## Product Change Notice (PCN)

**Subject:** Addition of Dicing sites for the RH850/F1 and D1 series.

**Publication Date:** 10/31/2022

Production flow

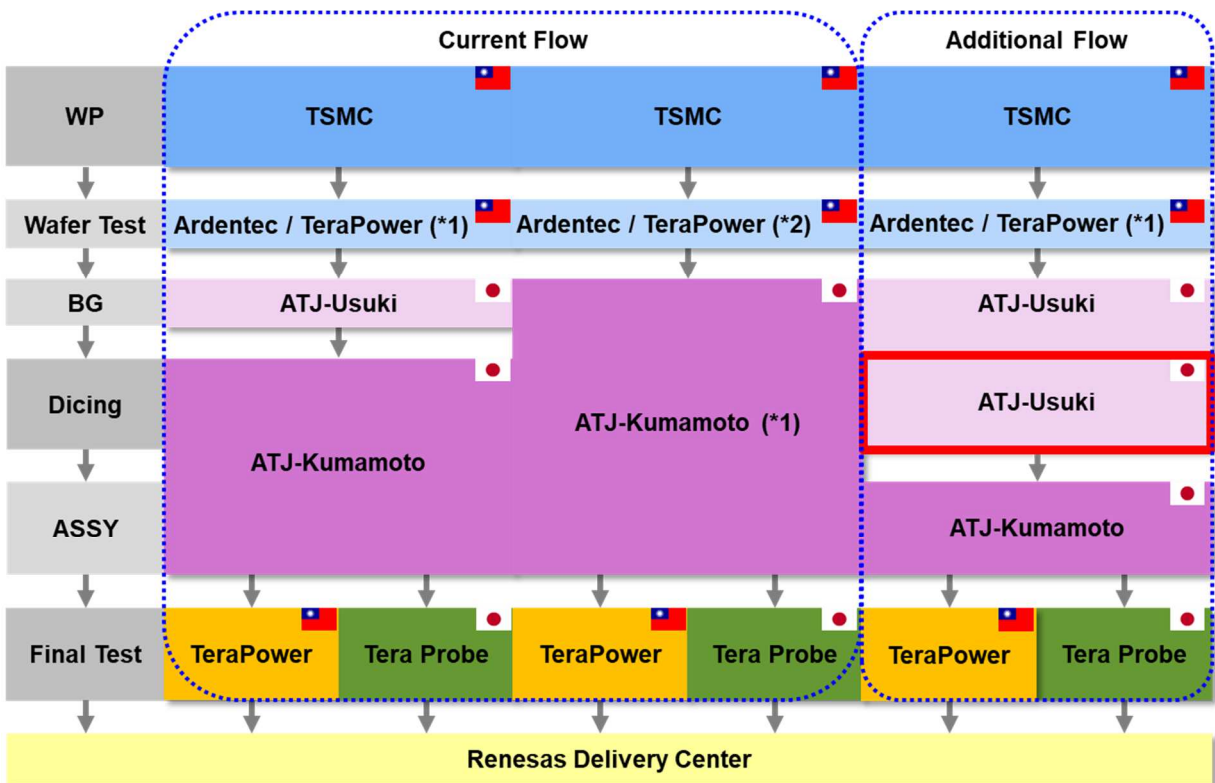
**Change items:** ATJ-Utsuki will be added in Dicing sites.

:Additional sites

2) Products : F1KM series

:Additional sites
